## **PLANNING BOARD AGENDA FOR JANUARY 13, 2026 - 7:00 PM**

1. **Salem NIM, LLC Site Plan** – Public Hearing for change of use for 19,960 sq. ft. restaurant and entertainment use with conditional use permit for reduced parking and additional signage at 11 Mall Road, Map 107, Lot 11154. Continued from 12/9/2025.

Below please find our responses comments discussed in our December 9 2025 meeting and at the PB meeting. Below please find each comment followed by our response in **bold**.

# LYONS GROUP RESTAURANT AT THE MALL AT ROCKINGHAM PARK PLANNING BOARD SUBMISSION

FM102 FIRE TRUCK MOVEMENT PLAN

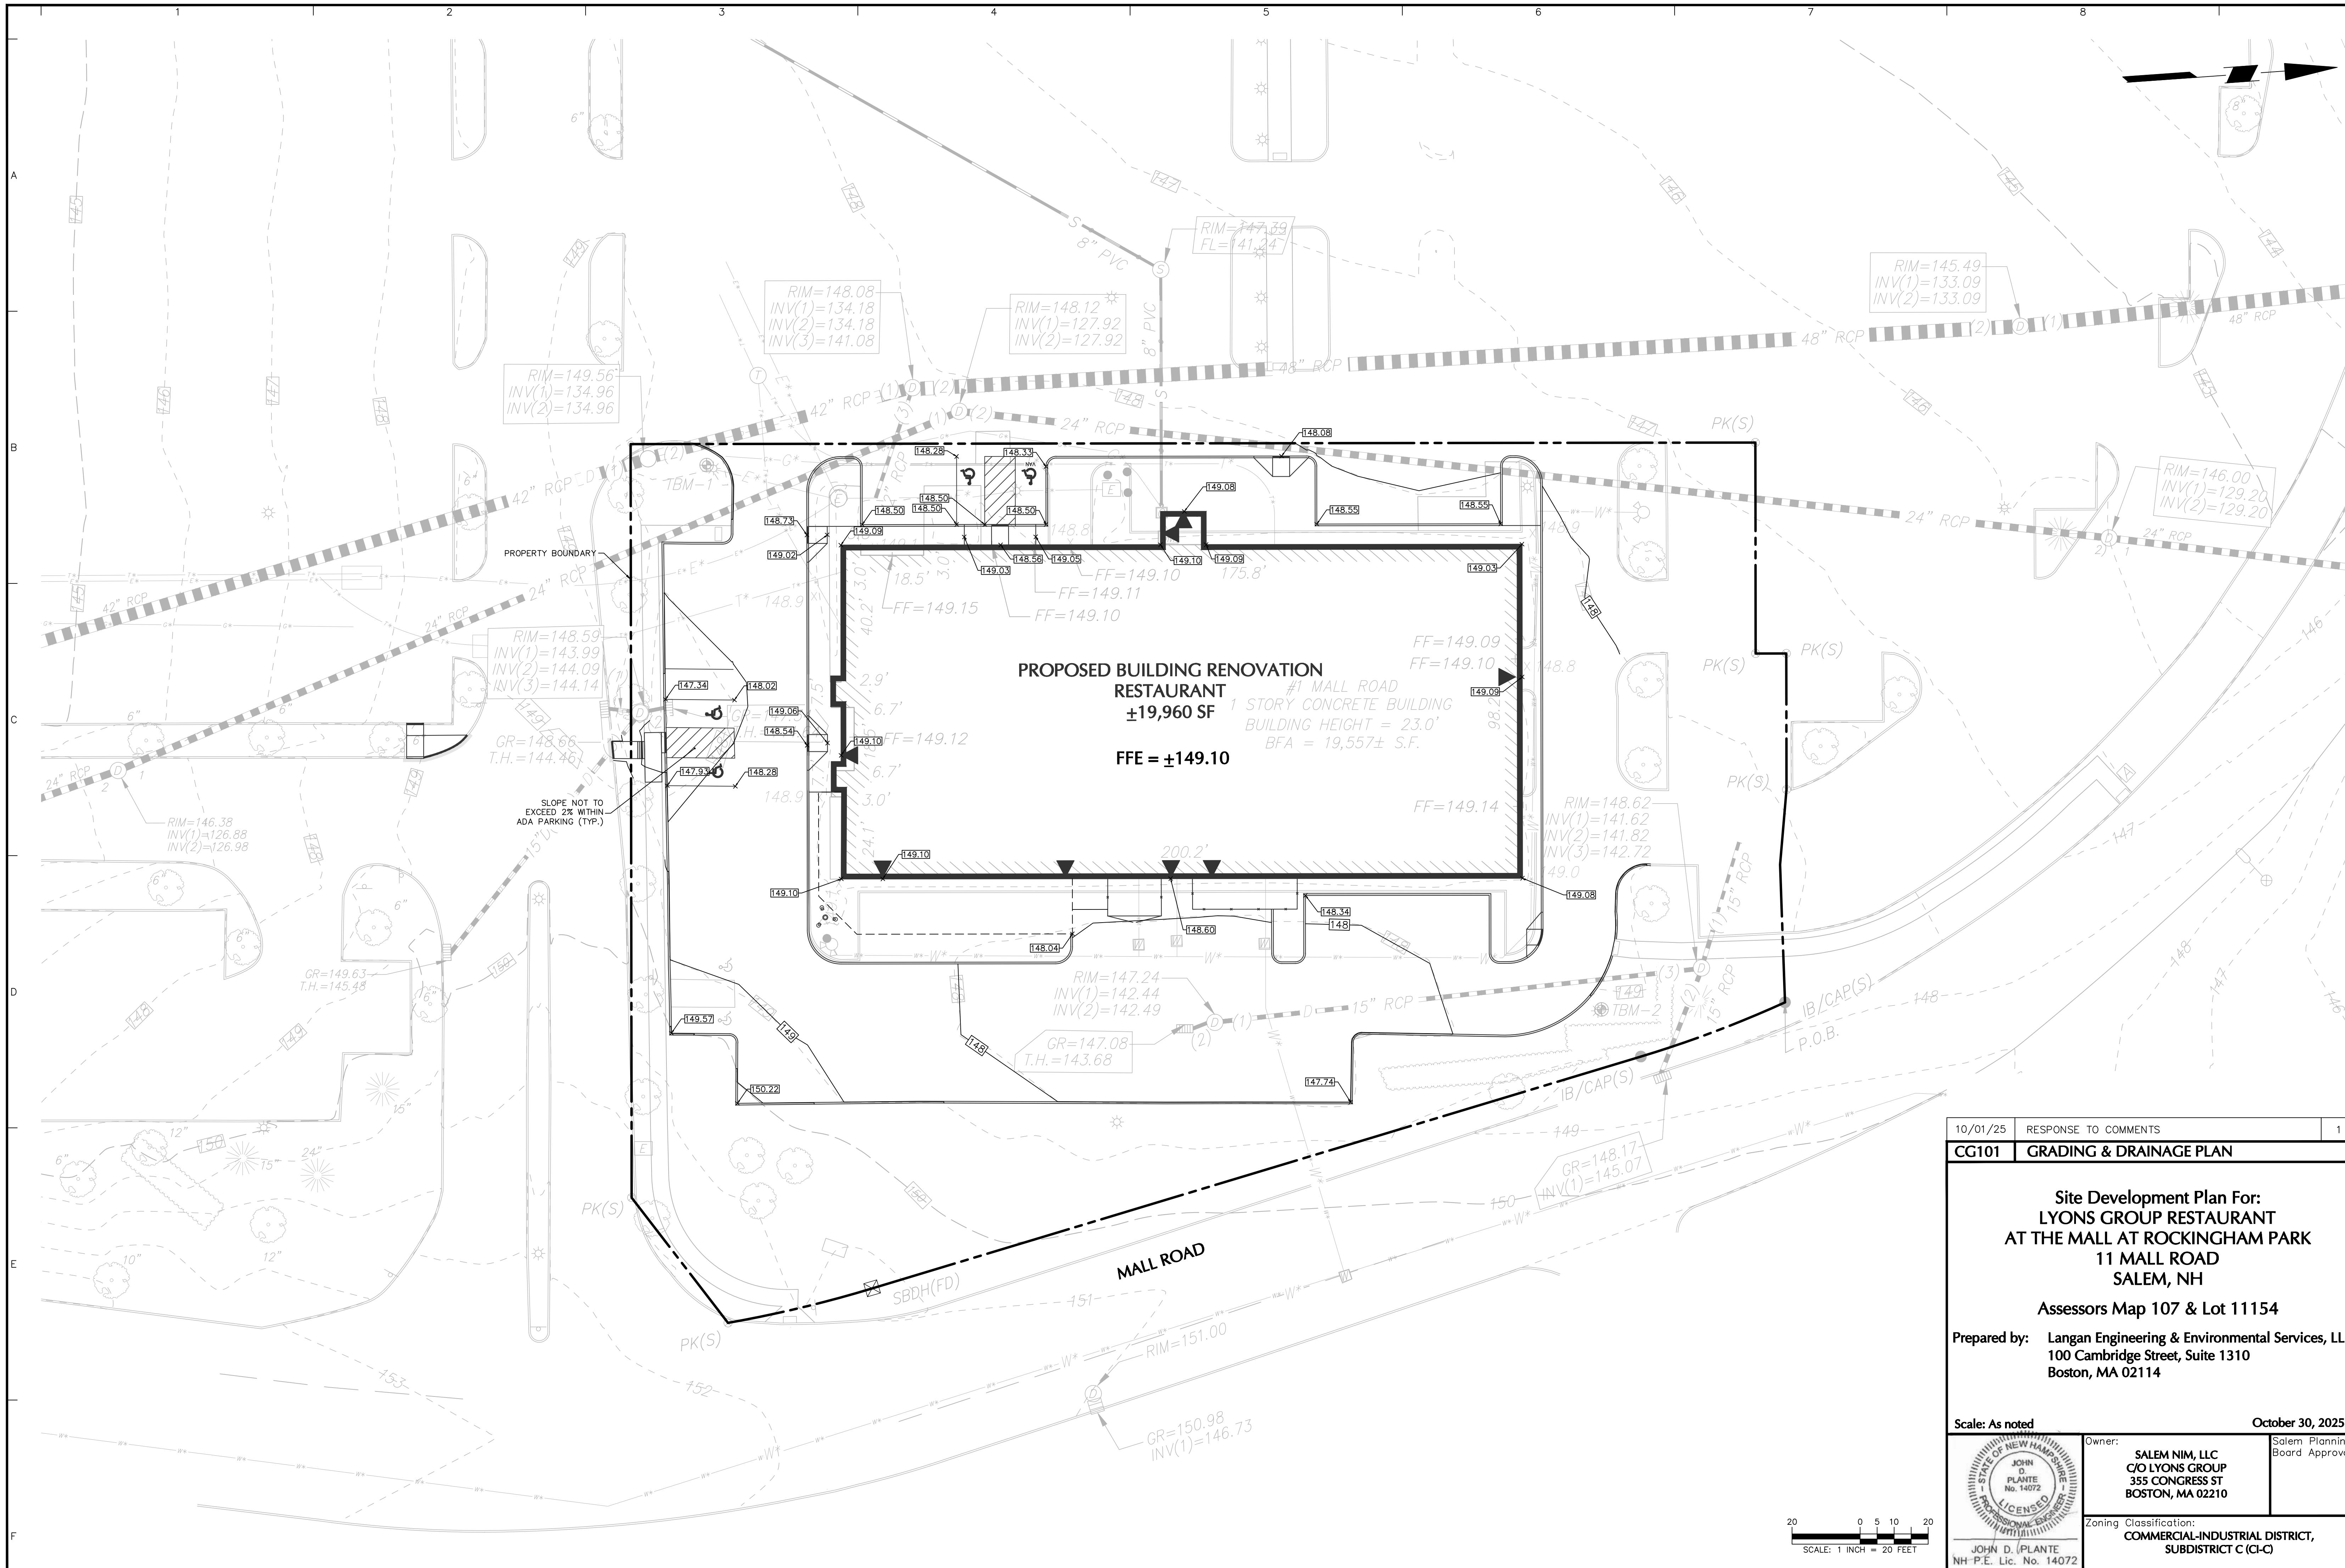
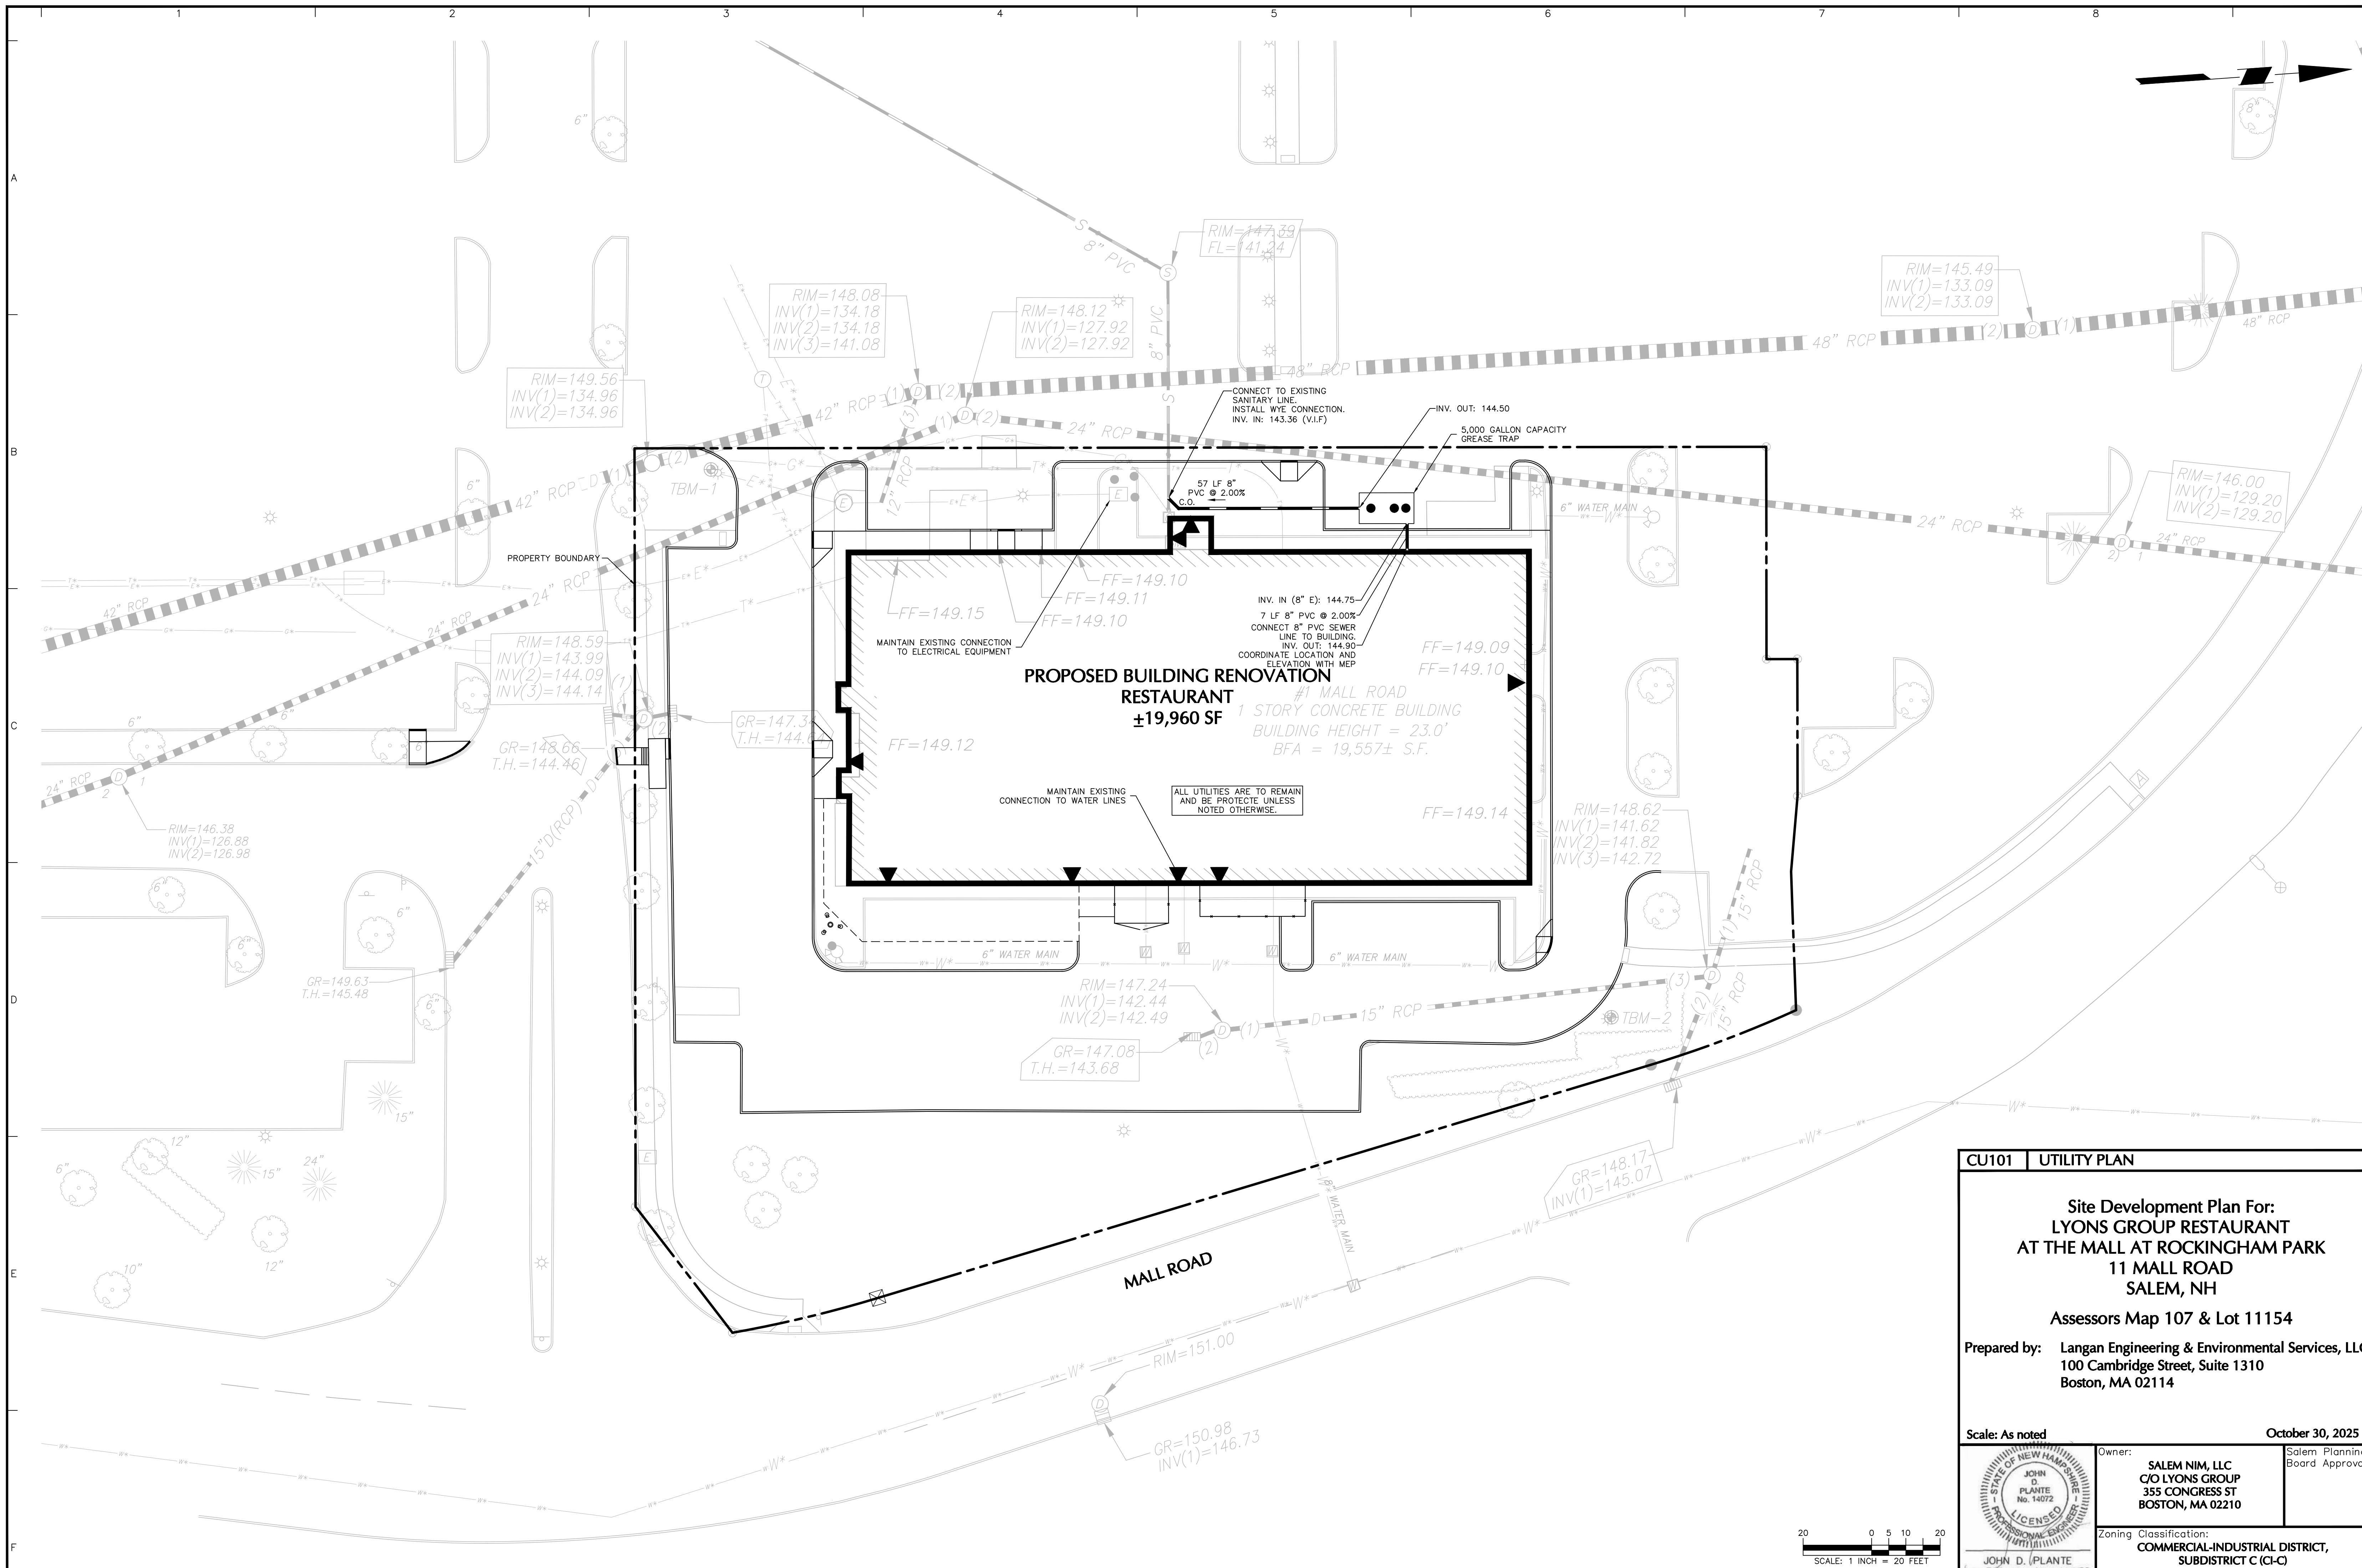
Site Development Plan – A vehicle tracking analysis should be prepared that demonstrates: 1) compatibility with Salem fire apparatus, and 2) how the dumpsters will be serviced. According to Sheet CS101, 68 spaces are proposed within the subject site. It should be noted that the peak parking demand estimates range from 158 to 395 occupied spaces. This means that there is the

**COMMENT RESPONSE: Vehicle turning movement demonstrations are provided on Sheets TM101 and TM102. The 85<sup>th</sup> percentile (peak) parking estimates for Loretta's and Game On! are 266 spaces, which is 71% of the available parking spaces within Lot C1.**
